ATTACHMENT 10 - Holroyd Development Control Plan 2013 Assessment

Requirement	Yes	No	N/A	Comments
PART A GENERAL CONTROLS				
2.1 Road design and construction Subdivision & new roads C5. Where the land is zoned for the purpose of a proposed new road, Council shall not consent to a subdivision of land of which the proposed road forms part unless the subdivision makes provision for the opening of a road in reasonable conformity with the proposed road. C6. Subdivision involving new roads shall conform to any site specific development controls for the area, showing the road network which satisfies projected district and regional travel. C7. If Relocation of services is required, it will be at the subdivider's expense. Council will also require reconstruction of such works where the Engineer deems this necessary in respect to existing facilities.	<input checked="" type="checkbox"/> <input checked="" type="checkbox"/> <input checked="" type="checkbox"/>	<input type="checkbox"/> <input type="checkbox"/> <input type="checkbox"/>	<input type="checkbox"/> <input type="checkbox"/> <input type="checkbox"/>	<p>The subject site includes land zoned SP2 for public road. The proposed subdivision la

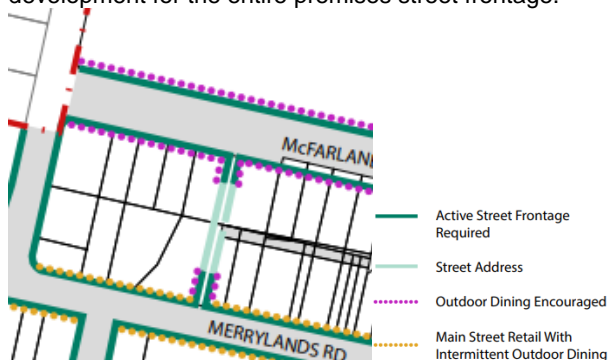
The development provides compliant side setback distances to the eastern property boundary from Building A, with a minimum of 12m provided across all levels of the development.

Compliant side setback distances are provided from Building E to the eastern property boundary, with the exception of Levels 3 to 7 which provide an 11m building setback to the eastern property boundary.

This non-compliance is considered minimal, given that the non-compliance applies to a small portion of the eastern building façade of Building E, noting that the majority of the façade complies with the 12m side setback.
